REMARKS

I. Status of the Claims

FIG. 4a

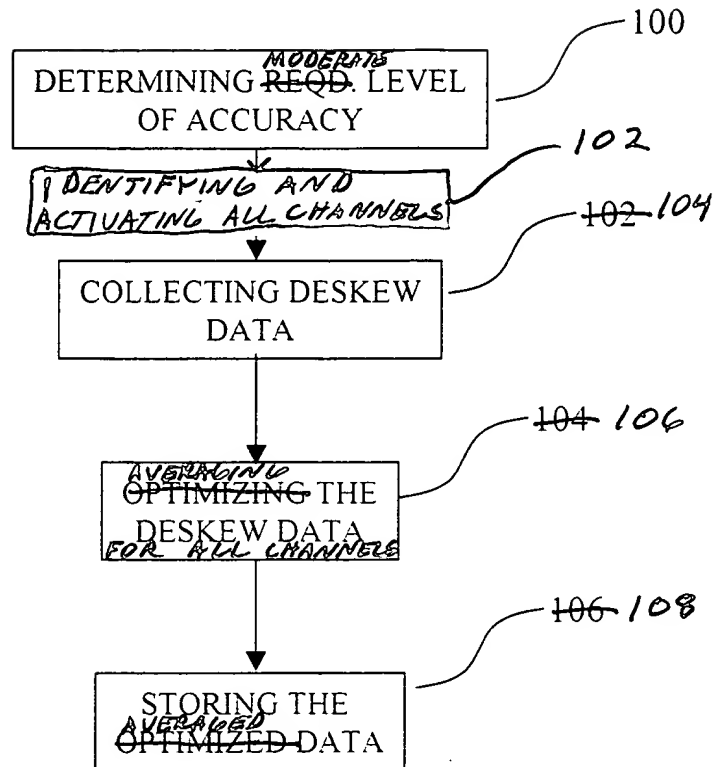
The Office Action identified informalities in the specification regarding the method steps of original Figure 4. The amending of Figure 4 into Figures 4a and 4b addresses the noted informality.

Minor informalities regarding Figures 3 and 4 were identified in the Office Action, and have been corrected consistent with the amendments herein. Red-lined copies of the figures are attached, as is a Letter to the Draftsman.
